Recall Bulletin

F/CMVSS NONCOMPLIANCE RECALL

SUBJECT: Passenger Side Instrument Panel Performance

MODELS: 2009-2014 Chevrolet Express
2009-2014 GMC Savana
1500 Series Equipped with Passenger Side Airbag (AK5))

3804499

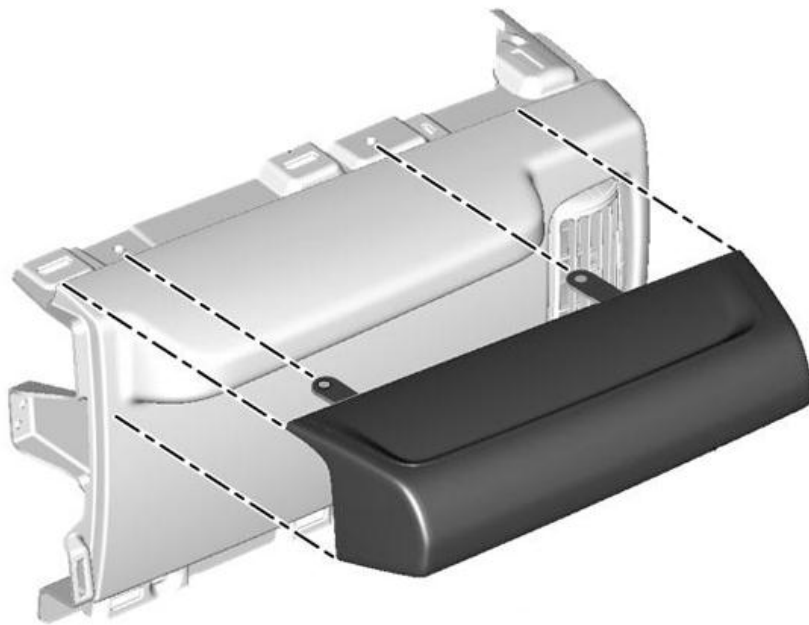
2. Remove the upper two screws that attach the instrument panel pad to the instrument panel bracket.

3. Inspect the brow assembly before installation to ensure the energy absorbing material is present.

4. Install the brow assembly to the instrument panel.

3785225

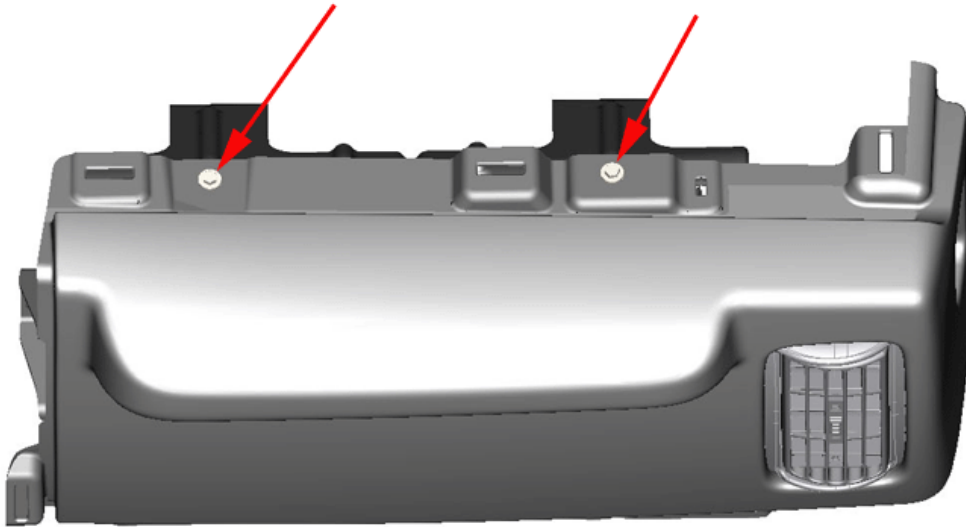
- Using the brow assembly as the template, drill two holes using an 8 mm (5/16 in) bit. The depth of the hole should be no more than 30 mm (1.25 in) deep.

- Install the two retainers.
- Install the instrument panel upper trim pad. *Refer to Instrument Panel Upper Trim Pad Replacement in SI.*

3804499

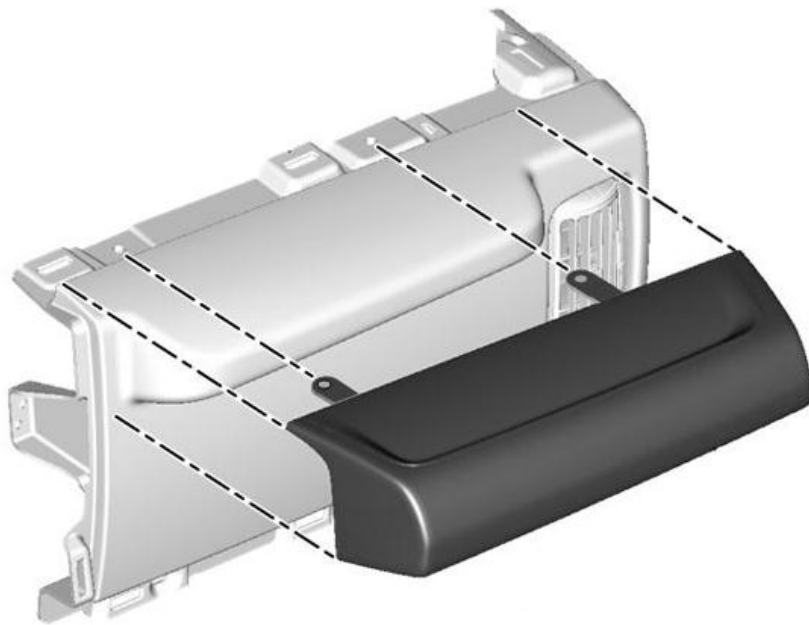
2. Remove the upper two screws that attach the instrument panel pad to the instrument panel bracket.

3. Inspect the brow assembly before installation to ensure the energy absorbing material is present.

4. Install the brow assembly to the instrument panel.
